Re: Revised Text In Section 2.2, Identification Of Interest For
Incidental Boundary Change - State Lease ML-43715

Re: Incidental Boundary Change
State Lease ML-43715

Re: Incidental Boundary Change
Geneva's State Lease ML-43715
For 22nd Left, #1 Mine

PROPOSED BC OF 95 ACRES

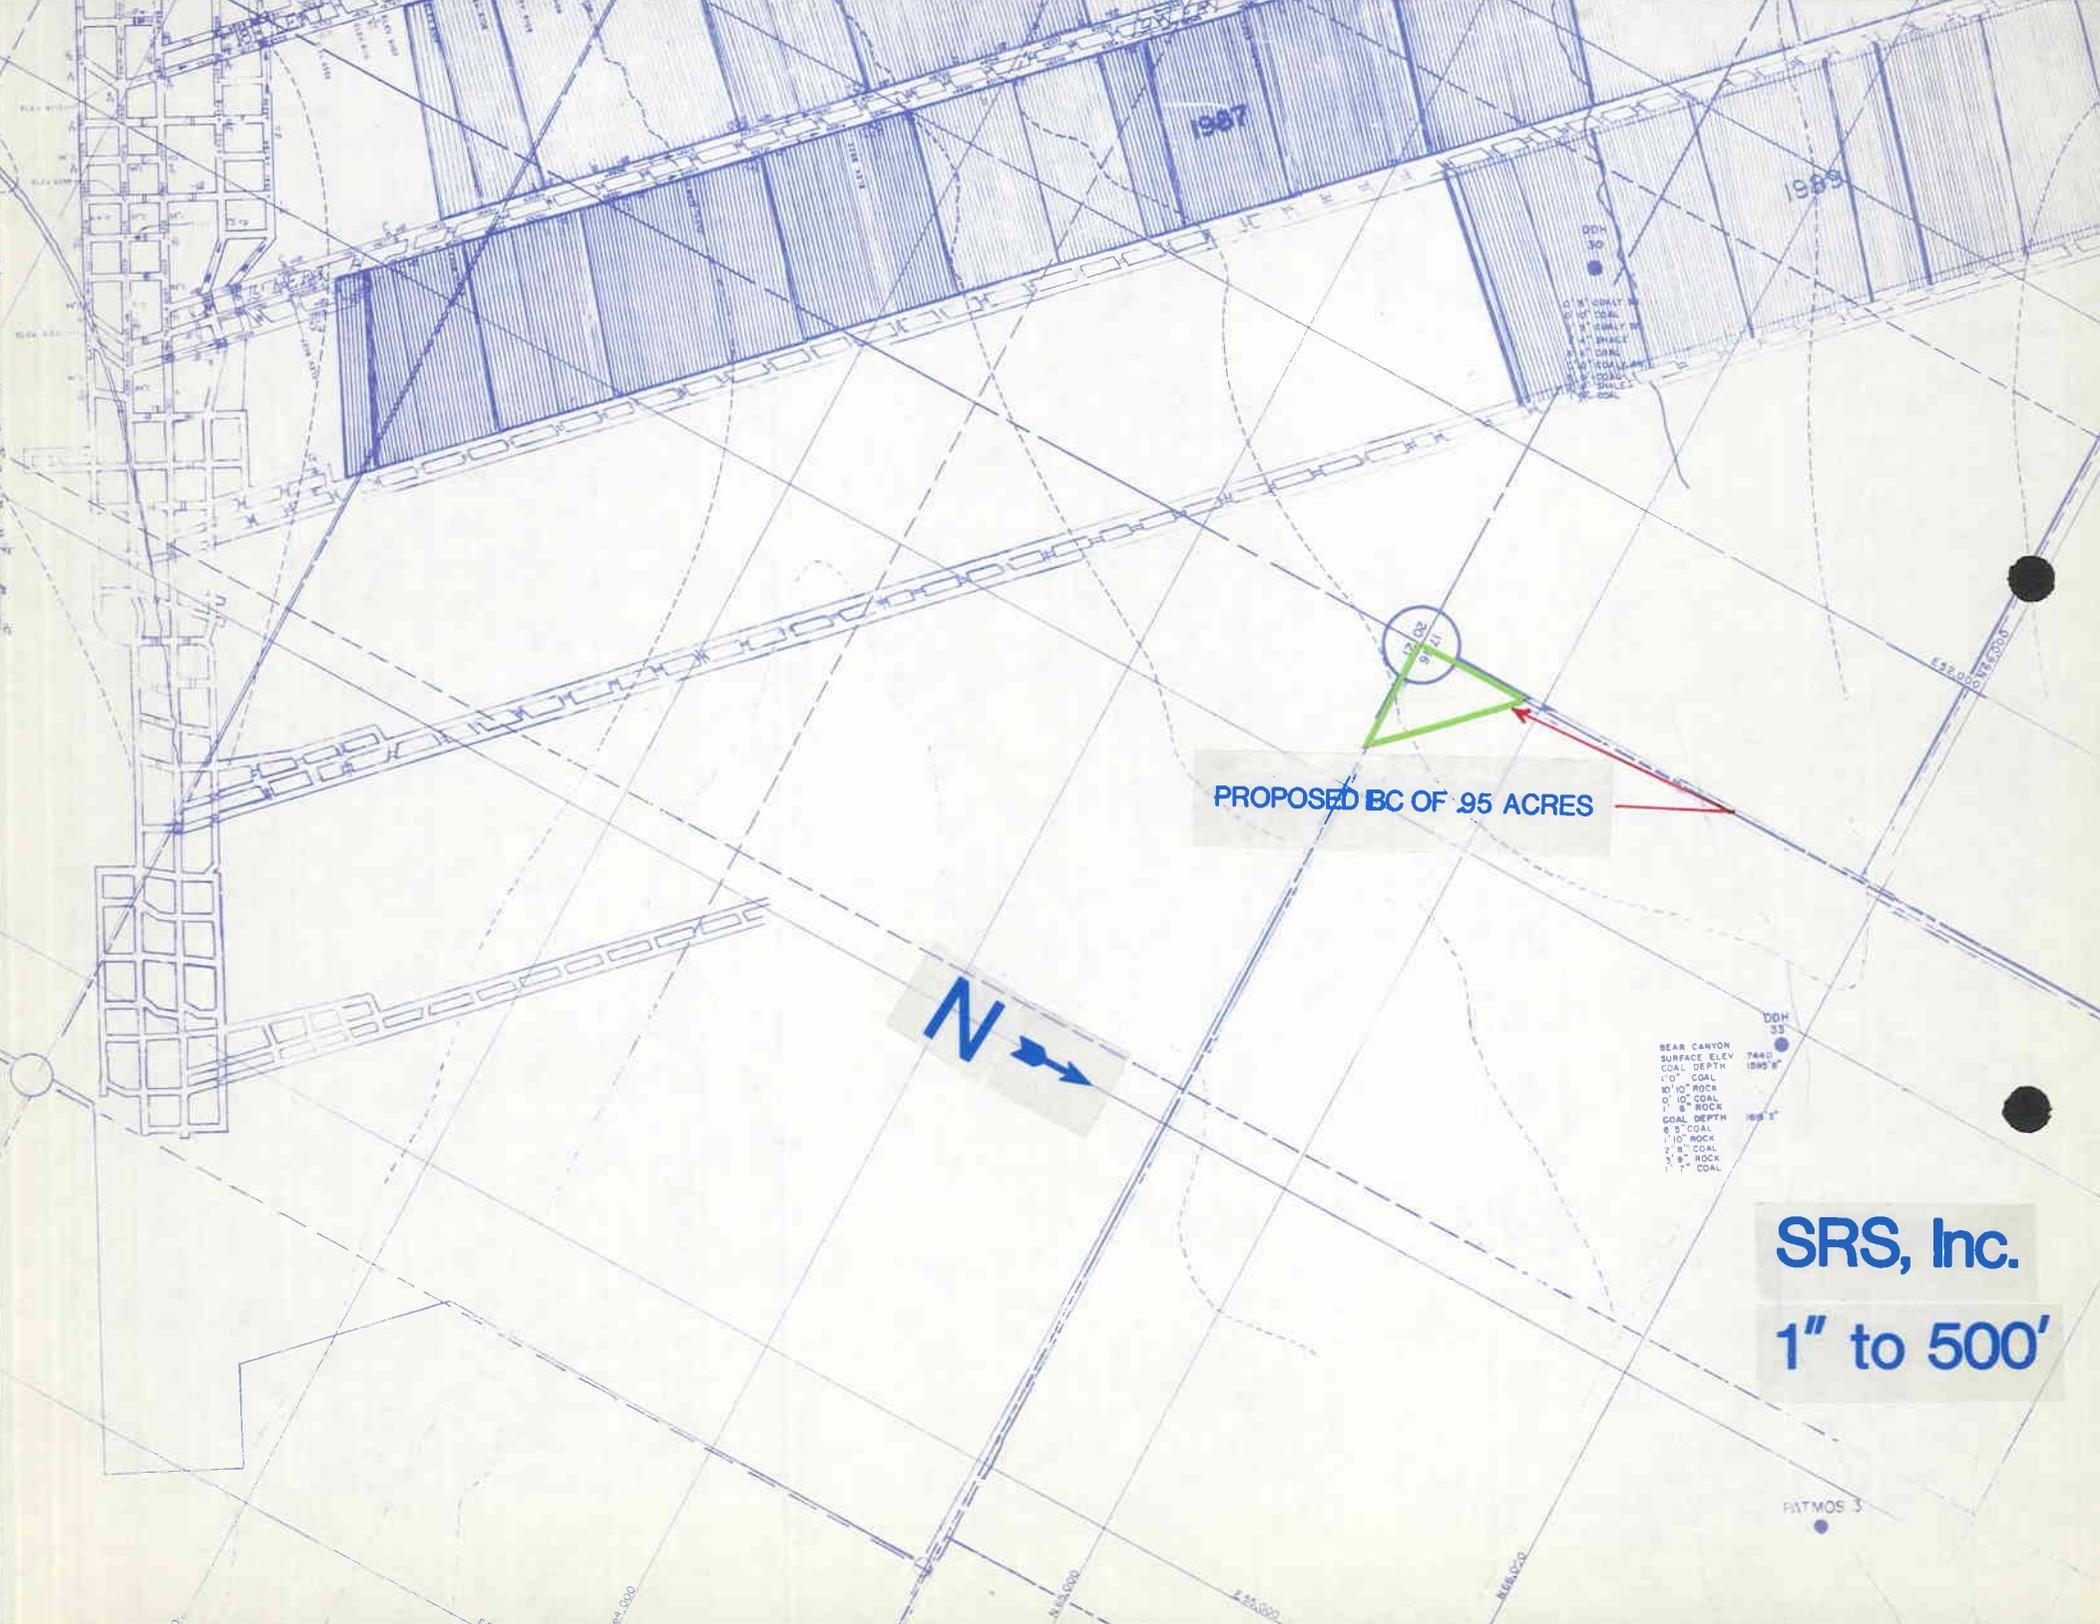
3. The five-year mining plan by year must be updated to show this addition (UMC 784.23 (a)).

Enclosed are five copies of the 25-Year Mine Plan, Plate III-3a, which has been updated to show the 5-year plan.

PROPOSED BC OF .95 ACRES

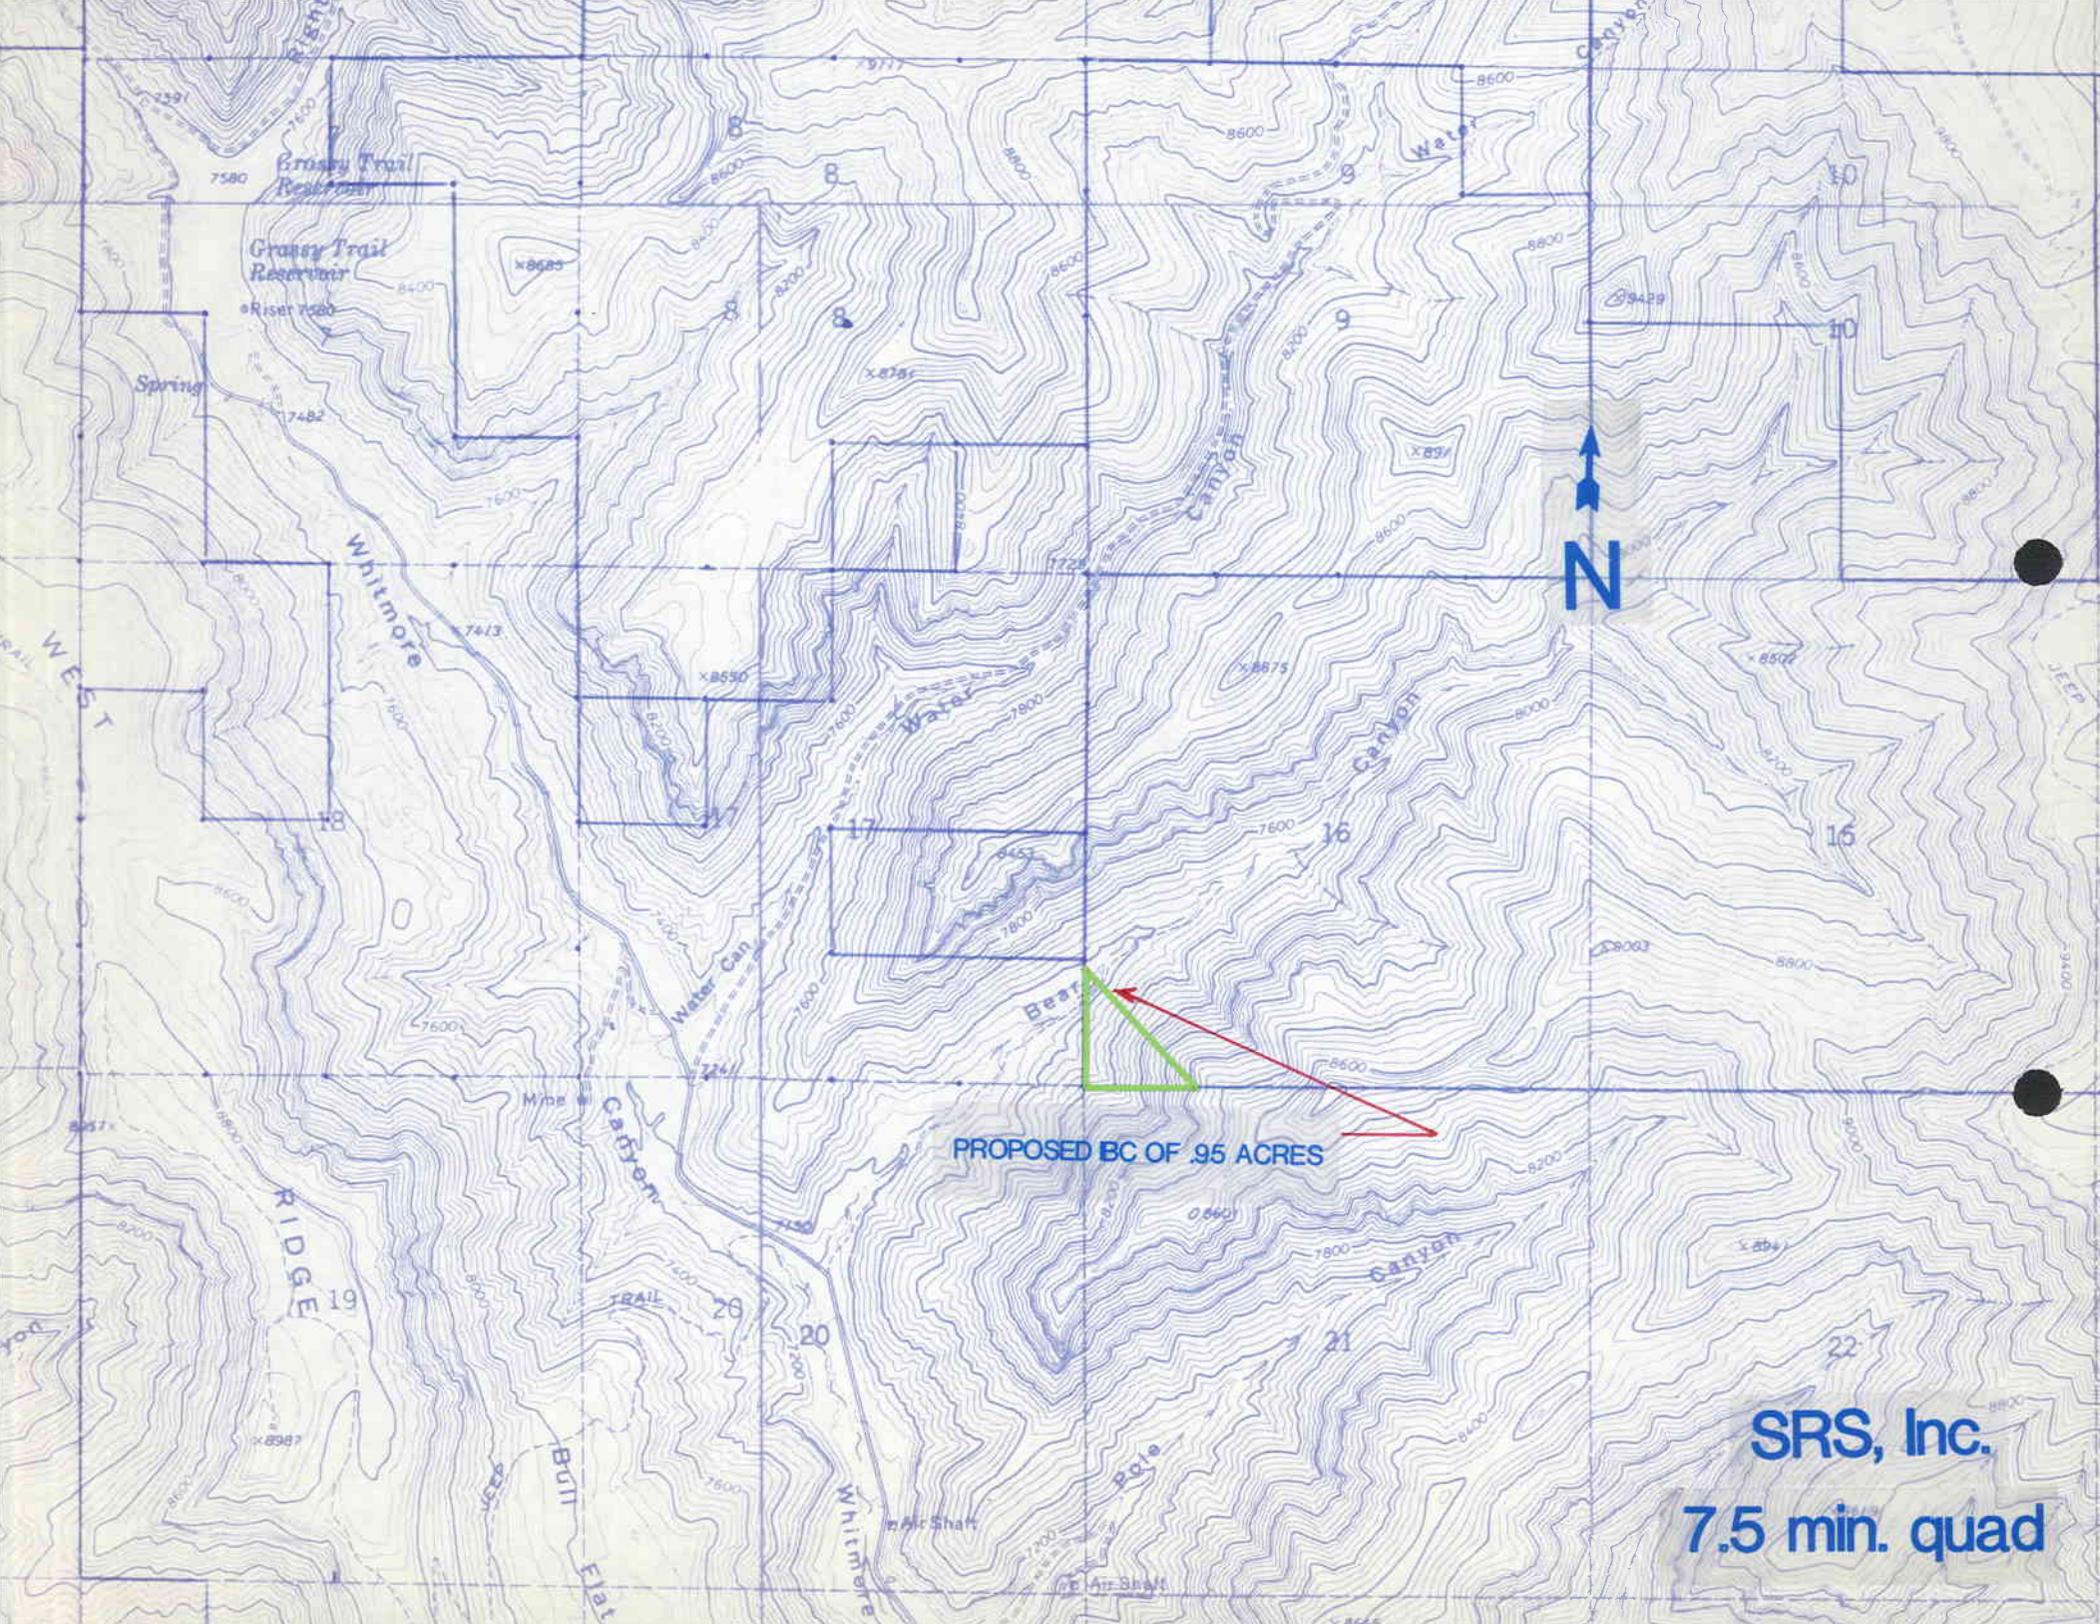
5. The permit area map must be updated (UMC 771.23 (b) and (e) (1)).

Enclosed are five copies of the updated Surface Facilities, Hydrology, and Pre-Law Disturbance Vegetation Map, Plate III-1, 2 of 3, which shows the permit area.
